SUBJECT:	VARIOUS TRAFFIC REGULATION ORDERS - AMENDMENT ORDER NO. 17 2025
MEETING:	INDIVIDUAL CABINET MEMBER DECISION – COUNCILLOR CATRIN MABY
DATE:	20/08/2025
DIVISION/WARDS AFFECTED:	WYESHAM, LLANTILLIO CROSSENNY, DRYBRIDGE, OVERMONNOW, MITCHELL TROY AND TRELLECH UNITED, RAGLAN, SHIRENEWTON, GOBION FAWR, BULWARK AND THORNWELL, ST ARVANS, DEVAUDEN, PORTSKEWETT, LLANGYBI FAWR.

- 1.1 This report seeks Cabinet Member approval to proceed with the making and implementation of the Monmouthshire County Council Traffic Regulation, Speed Limits and Parking Regulations Consolidation Order 2019 (Amendment Order No. 17) 2025.

Appendix 1: Schedule of Consultation Responses

2224 Mitchell Troy Road, Raglan Proposed 40mph Speed Limit

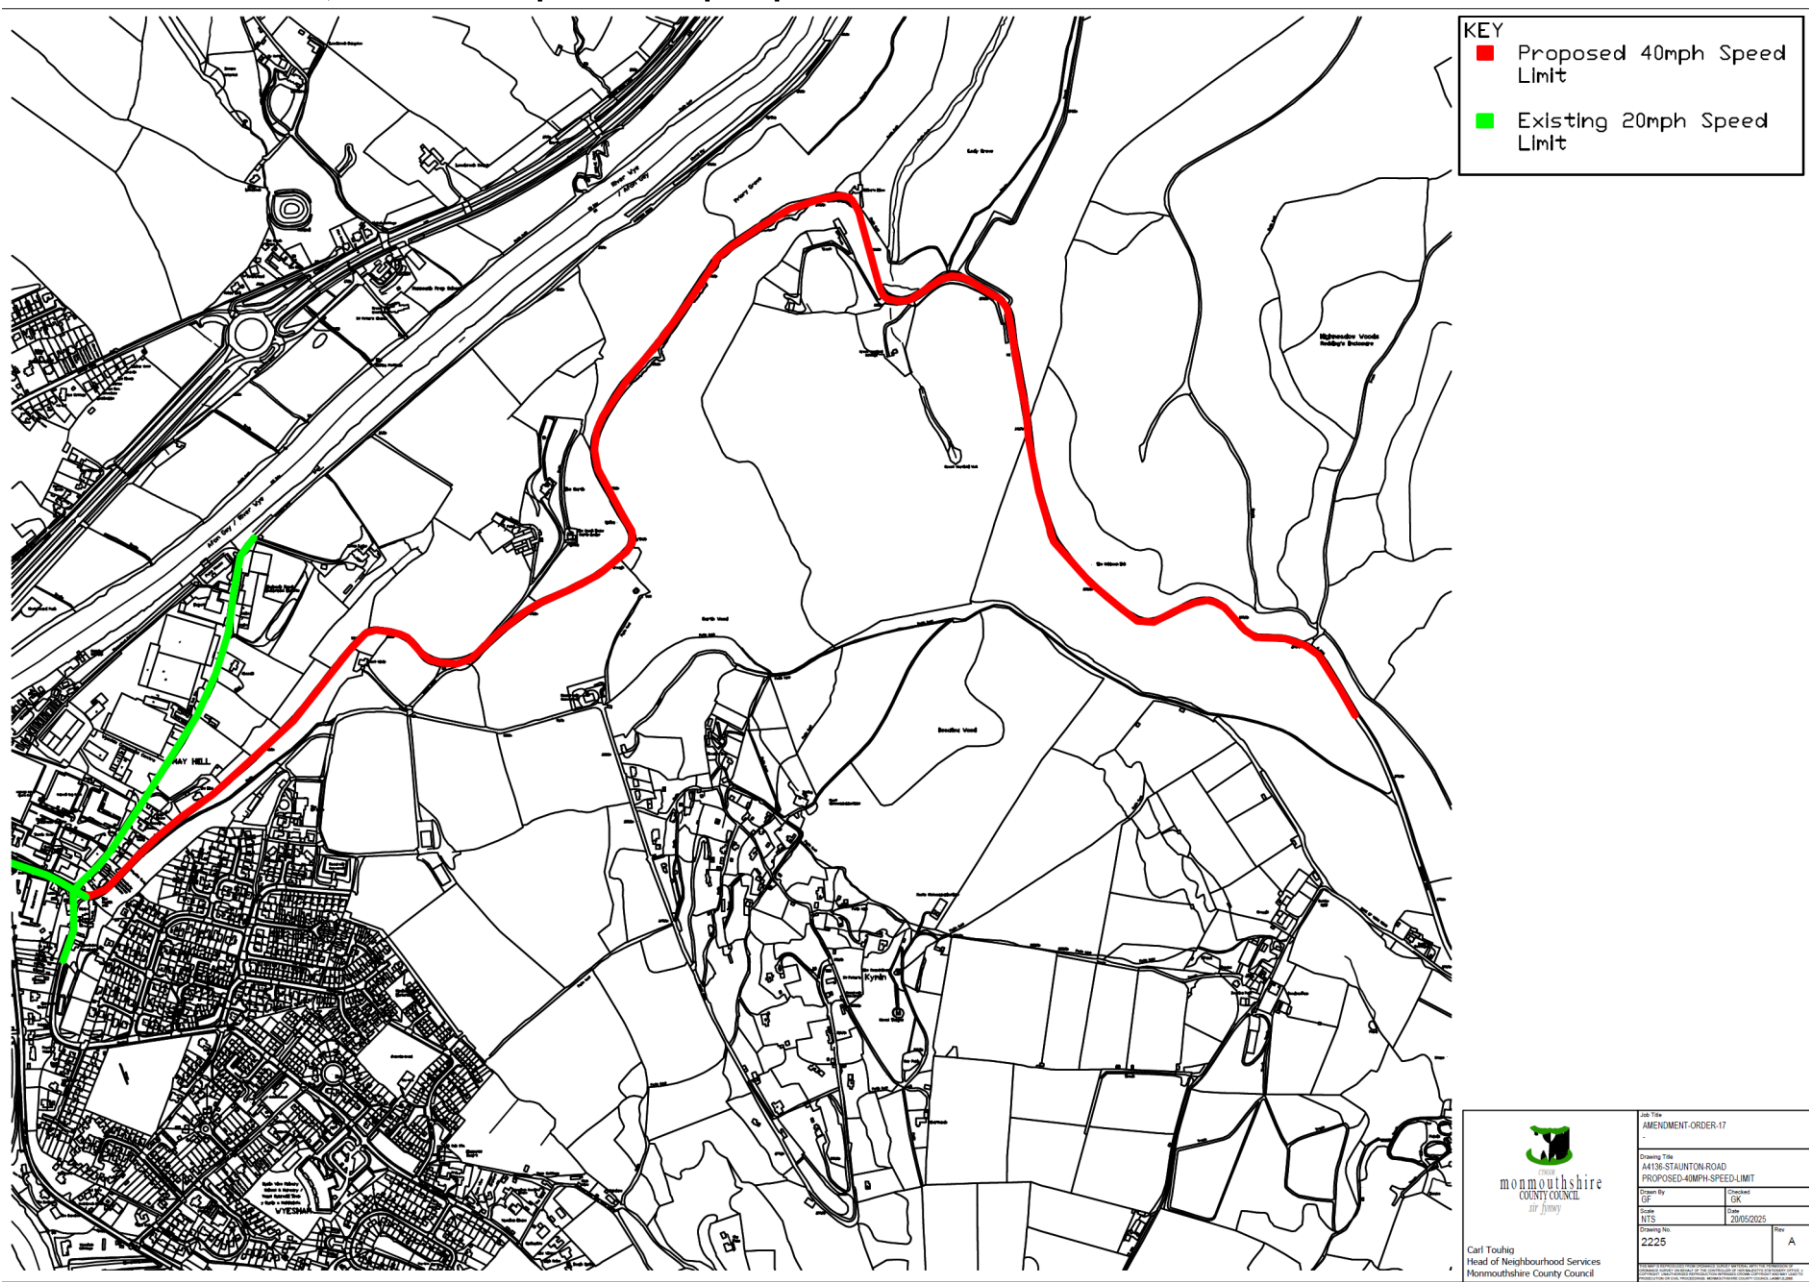
645	Yes	2224 Mitchell Troy Road, Raglan - Proposed 40mph Speed Limit (AO17)	This is the road directly off the A40 where cars exit at very high speed and it is a residential area. A reduction in speed limit will make it safer for residents particularly when walking from or driving off from their homes.	Ref 645 Your support for this proposal is noted.
646	Yes	2224 Mitchell Troy Road, Raglan - Proposed 40mph Speed Limit (AO17)	I live on this stretch, the volume of traffic and the speed they travel is increasing, and the type of traffic due to neighbouring business and farm land is also bigger (with more powerful engines) increasing the risk of fatality if injured. It is dangerous to get in and out of your vehicle, to pull off from the road. I have	Ref 646 Your support for this proposal is noted.

648	Yes	2224 Mitchell Troy Road, Raglan - Proposed 40mph Speed Limit (AO17)	Make it safer for us pulling out of our junction on Warrage Road. We also quite often walk to neighbours on that road, with our baby daughter, and the speed in which some drivers pass us is frightening and we do not feel safe doing so. Would welcome a reduction to 40mph	Ref 648 Your support for this proposal is noted.
649	No	2230 A466, Llandogo - Proposed revocation of existing 20mph Speed Limit (AO17)	The 20mph speed limit has been noticeably successful in making the village a safer environment. The revocation of this limit would therefore be a backward step. Many places in England Scotland and Wales now benefit from this; why should 'Llandogians' be unfairly treated? Statistics show that the fewer accidents save the NHS money. Children, elderly people, dog walkers, tourists etc. access the village facilities through these limited areas. I would be beyond disappointed, and bewildered, if the limit were revoked	Ref 649 This proposal is a legal administrative exercise only and will result in no material change to the 20mph speed limit on the ground. The area is classified as a 'restricted road' with compliant street lighting, which means it is automatically subject to a 20mph limit under national regulations. Revoking the redundant, separate order provides legal clarity and eliminates enforcement complications while maintaining the 20mph speed environment. This was explicitly stated in both the Statement of Reasons and drawing 2230.

2226 B4235, Chepstow to Mynydd Bach Proposed 40mph Speed Limit

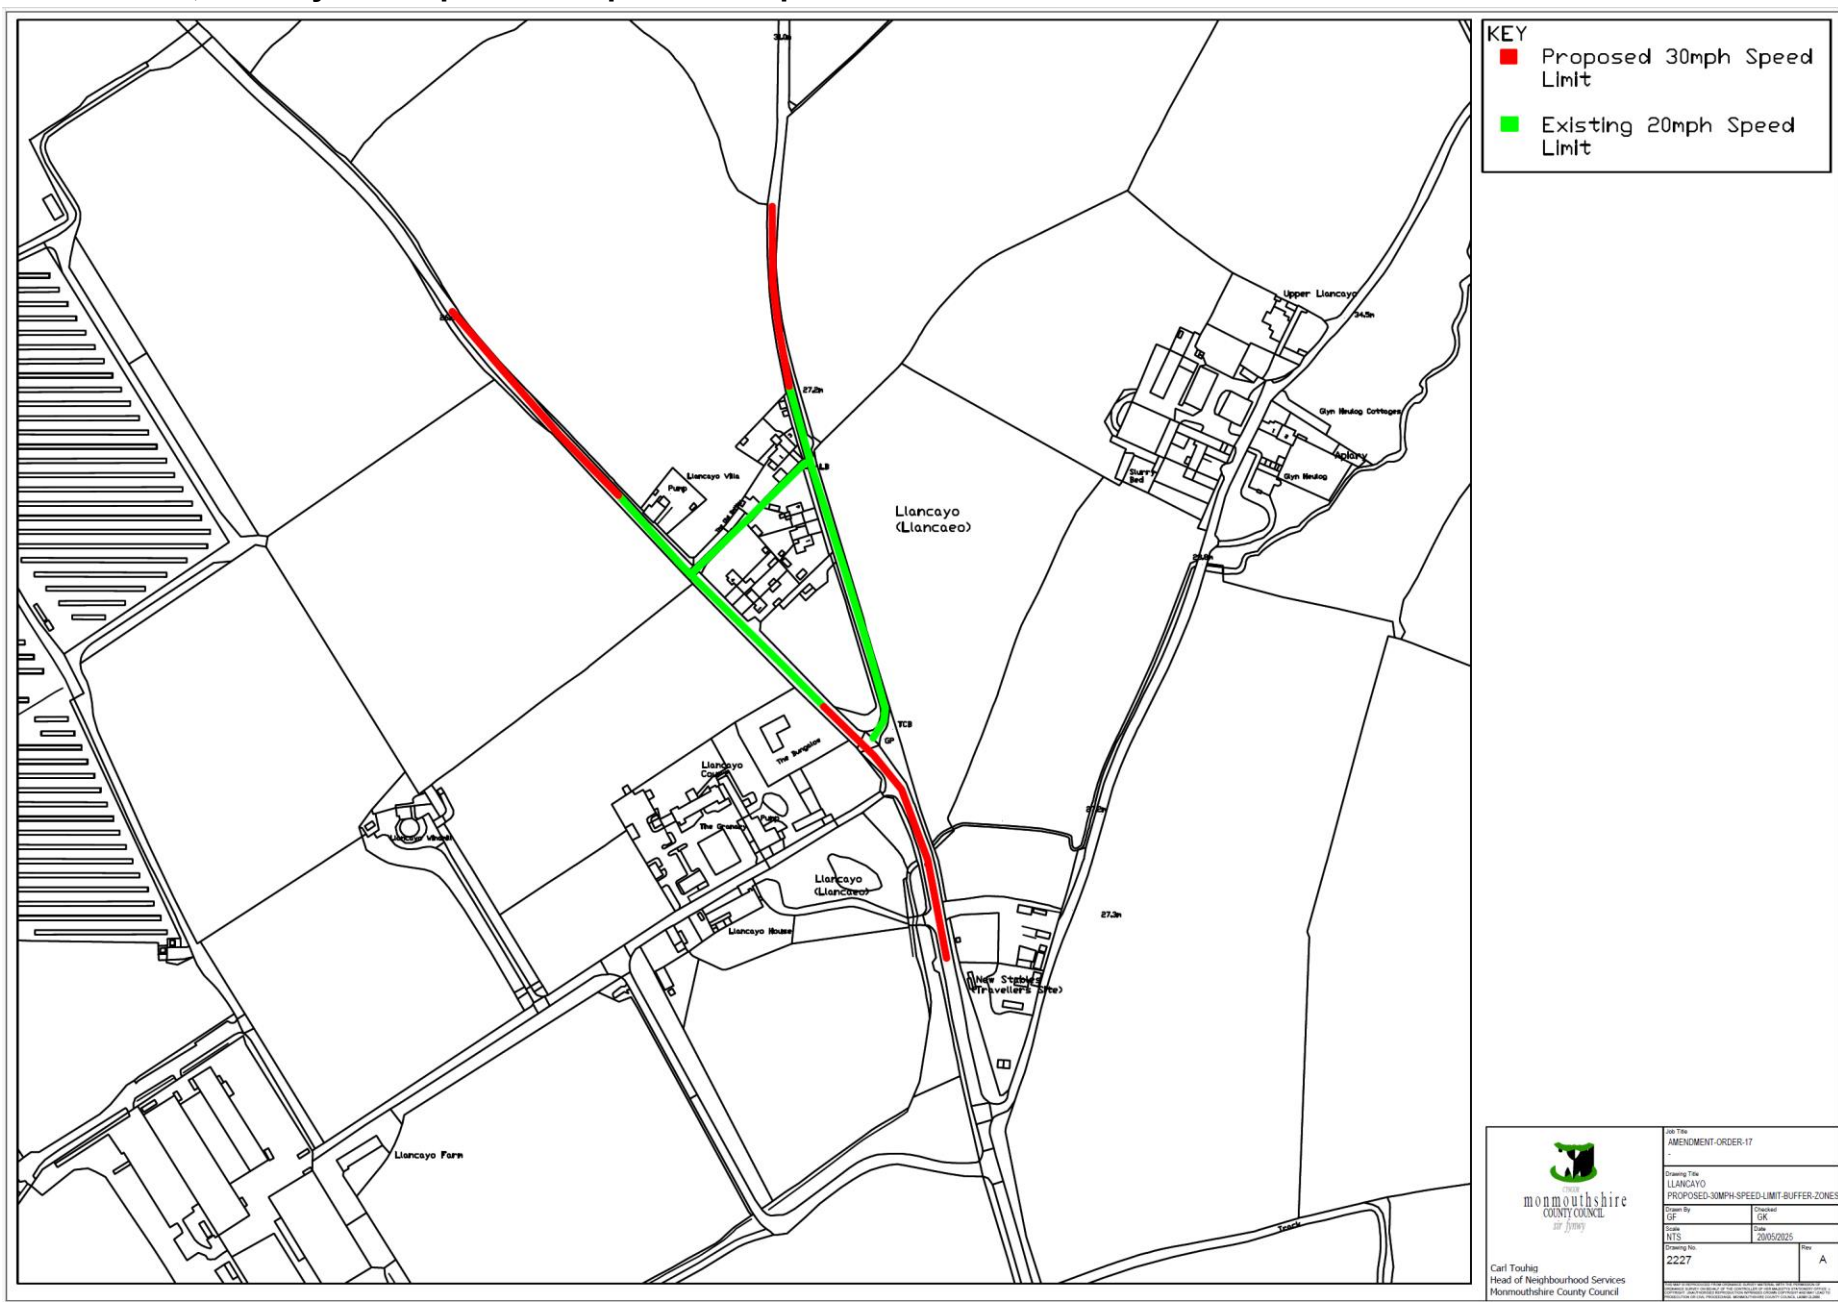
660	Somewhat	2226 B4235, Chepstow to Mynydd Bach - Proposed 40mph	The exercise will be pointless without enforcement. Gwent police have done little to no enforcement of the solid white lines on this road and rely entirely on dash cam evidence submitted to Go	Ref 660 Your comments regarding enforcement are noted. The establishment of a legal and appropriate speed limit is the necessary first step for any enforcement activity.

682	Yes	2226 B4235, Chepstow to Mynydd Bach - Proposed 40mph Speed Limit (AO17)	Fully support extending the 40mph from Mynyddbach to Chepstow. The B4235 is one of the most accident prone roads in Monmouthshire. We regularly have multi-agency meetings every quarter with highways, police and Go Safe, myself and community council representatives. We would also like consideration to be given to extending this 40mph from the Shirenewton end as discussed at the last meeting, taking account of the Gaerllwyd Junction.	Ref 682 Your support for this proposal is noted.
683	Yes	2222 B4293, Mitchell Troy - Proposed 40mph Speed Limit (AO17)	Really needs to be 30 mph because of the road round the bridge and the blind corner at the Toll House	Ref 683 Thank you for your representation. Following the consultation period, an error was identified in the advertised proposals for this location. As a result, it has been decided not to proceed with this specific order at this time. The safety concerns on this route will be subject to a future

2228 Common Road, Mitchell Troy Proposed 20mph Speed Limit

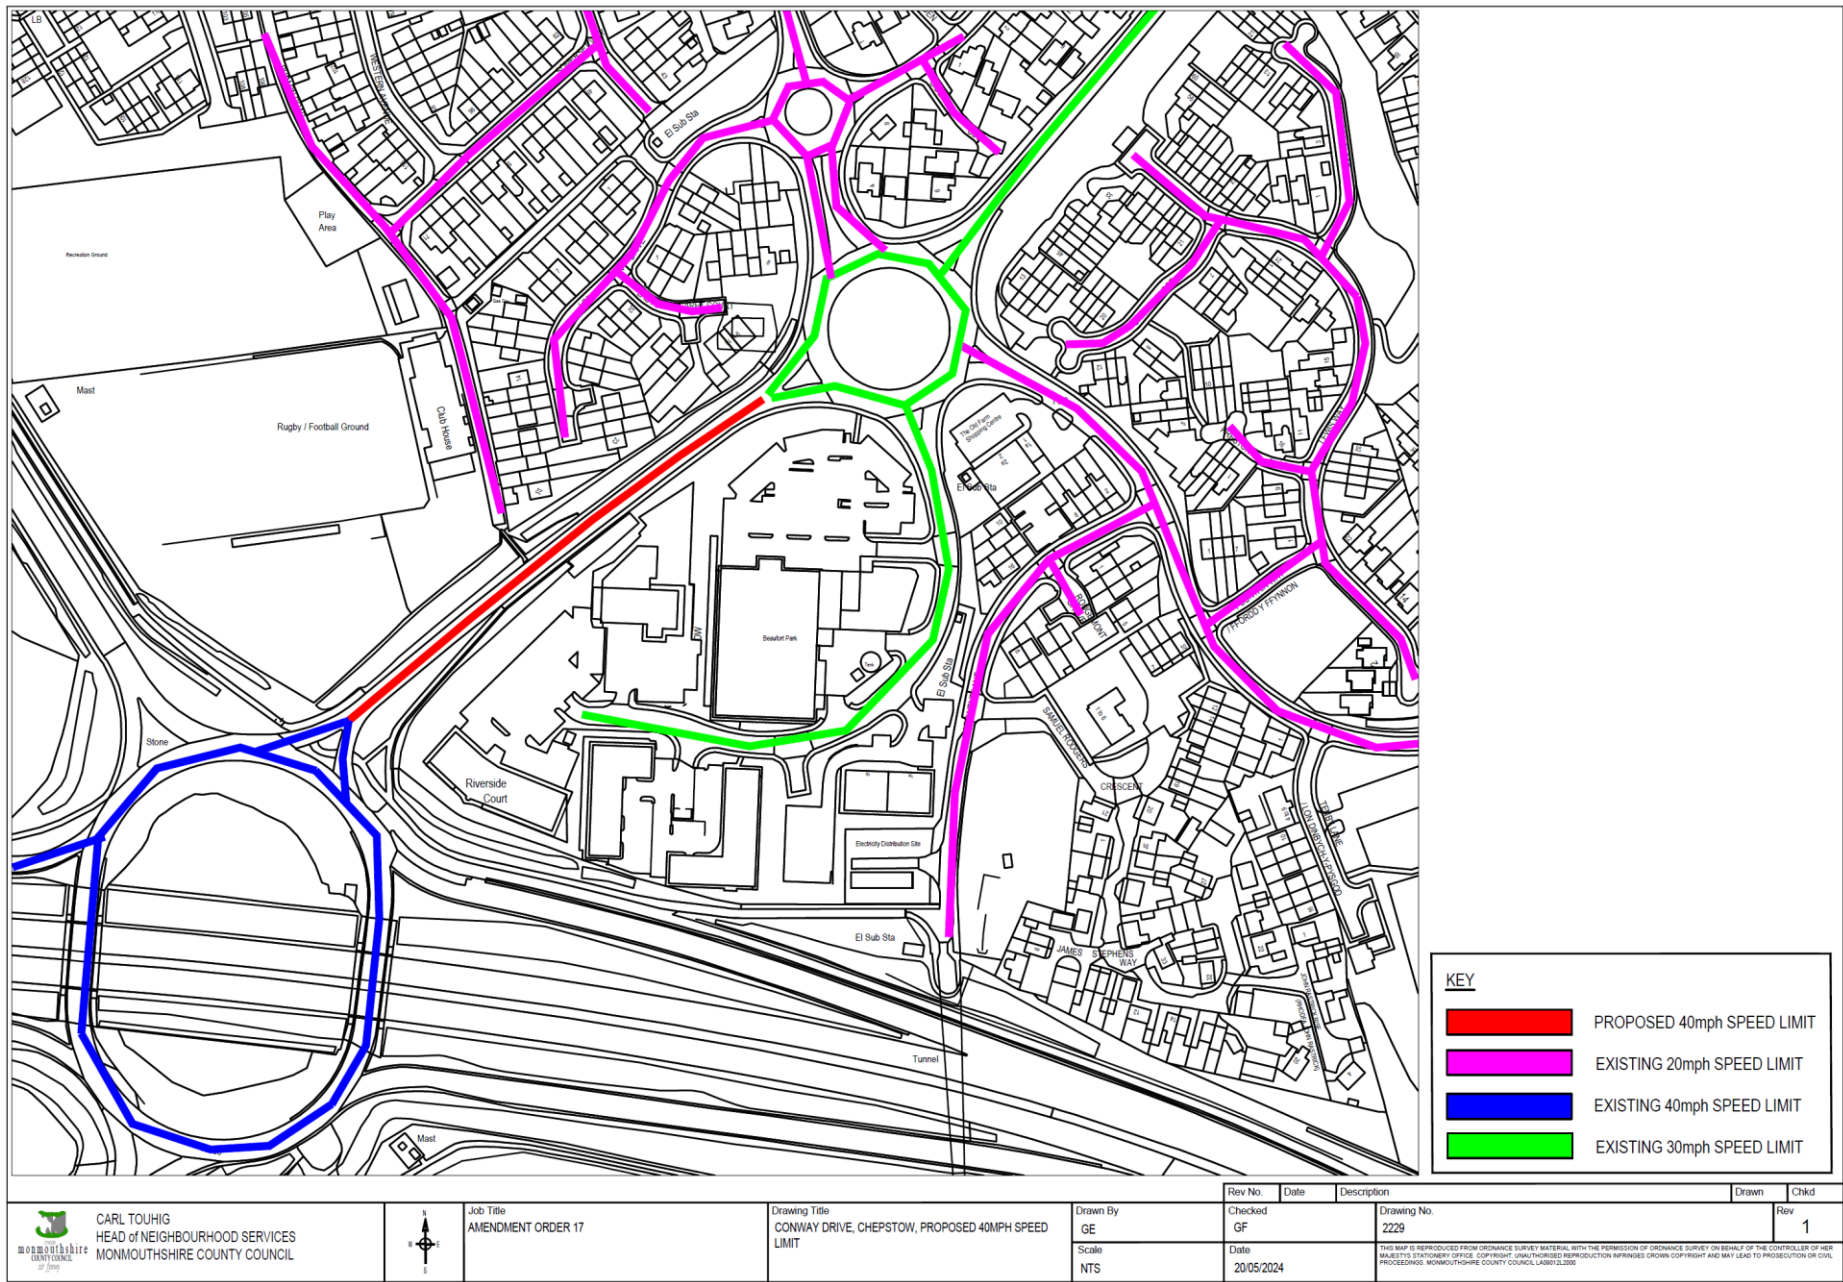
639	Yes	2228 Common Road, Mitchell Troy - Proposed 20mph Speed Limit (AO17)	This road is narrow with a few sharp bends. It is used as a cut through by drivers who clearly drive too fast and underestimate how narrow it is and how sharp the bends are. Our driveway leads onto Common Road and we frequently have drivers almost clipping our car as we turn into Common Road. The road is also used by dog walkers and to walk horses across from the fields. I welcome a 20mph speed restriction as it is not safe or sensible to drive any faster than that on this road.	Ref 639 Your support for this proposal is noted.
640	Somewhat	2223 B4293, Mitchell Troy - Proposed 50mph Speed Limit (AO17)	I support a reduced speed limit as I agree with the assessment that there are sections of this road that are dangerous particularly around the toll house. However I would advocate for a speed of 40mph rather than 50mph as given the lack of visibility near the toll house and drivers to ignore speed limits and exceed them by at least a small amount, 50mph feels too fast to be safe.	Ref 640 Thank you for your representation. Following the consultation period, an error was identified in the advertised proposals for this location. As a result, it has been decided not to proceed with this specific order at this time. The safety concerns on this route will be subject to a future review, and any new proposals will undergo a separate public consultation.

642	Yes	2228 Common Road, Mitchell Troy - Proposed 20mph Speed Limit (AO17)	Living on Common Road we see vehicles driving at speed past our house. We live on the bend before Rocklea and pulling up to reverse onto our drive feels like we are sitting ducks as vehicles come around the blind bend at considerable speed	Ref 642 Your support for this proposal is noted.
643	Yes	2217 A472, The Rhadyr, Usk - Proposed 40mph and 30mph Speed Limit (AO17)	We are in favour of this limit change due to the amount of junctions and slow moving traffic around the current change of the limit from 40mph to the 60 mph national. The ability to join the A472 safely from our own property is a priority for us too.	Ref 643 Your support for this proposal is noted.
644	Yes	2217 A472, The Rhadyr, Usk - Proposed 40mph and 30mph Speed Limit (AO17)	I think this is a very sensible proposal, and I support it's implementation. Traffic often moves at high speed along this stretch of road and it is often difficult to turn in and out of the junction, particularly at the beginning and end of the BAE working day.	Ref 644 Your support for this proposal is noted.

662	Yes	2228 Common Road, Mitchell Troy - Proposed 20mph Speed Limit (AO17)	The whole of Common Road should be made 20 or 30 including the section currently 50mph from Swallow Barn to the Garthi Close area (currently 20) There is housing along the section; there is no pavement though there are many walkers along the section. There is also a footpath opposite Swallow Barn by which time traffic is already travelling up to 50mph, many of whom have gone through the village well in excess of 20mph. an occasional mobile camera discreetly placed might be quite revealing!	Ref 662 The current proposal is to rectify an administrative omission where this section of road was inadvertently left out of the legal order, despite being signed as 20mph. Your comments regarding extending the zone are noted; however, this proposal is focused on ensuring the existing signed limit is legally enforceable.
663	Yes	2222 B4293, Mitchell Troy - Proposed 40mph Speed Limit (AO17)	The exit from the Millbrook Garden Centre and St Dial's Farm is very dangerous as many drivers pull out without checking both ways. Also some motorists overtake at this point when heading away from Monmouth which exacerbates the problem	Ref 663 Thank you for your representation. Following the consultation period, an error was identified in the advertised proposals for this location. As a result, it has been decided not to proceed with this specific order at this time. The safety concerns on this route will be subject to a future review, and any new proposals will undergo a separate public consultation.

675	No	2228 Common Road, Mitchell Troy - Proposed 20mph Speed Limit (AO17)	Totally unnecessary. Just burning more fuel trying to get up the hill at such slow speeds.	Ref 675 This proposal is to rectify an administrative inconsistency. The section of road is already signed as 20mph and operates as part of the wider 20mph area but was inadvertently
